Change of Cover Plate to LLFS 90

2. Technical Change

LLFS 90 Old design		LLFS 90 New design

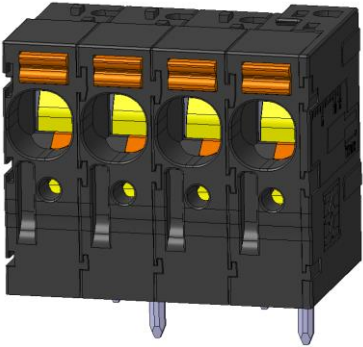
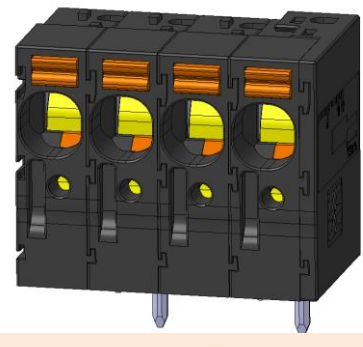
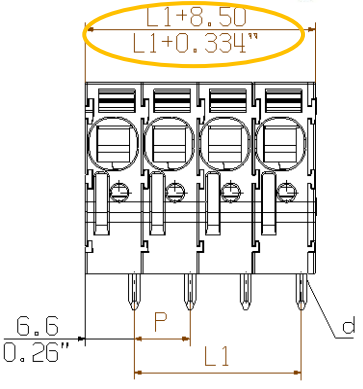
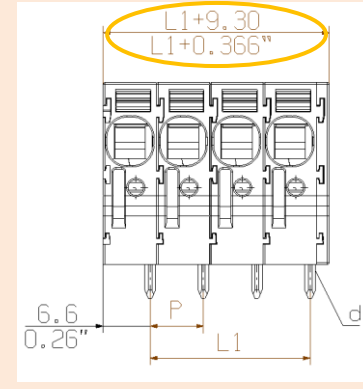
The geometry of cover plate will be changed to LLFS 90° version.

The cover plate of the outside pole position has been improved to be more stable while bending biggest connected solid wires.
The overall dimension has increased as shown in section 2. There is no influence on electrical data in the data sheet.
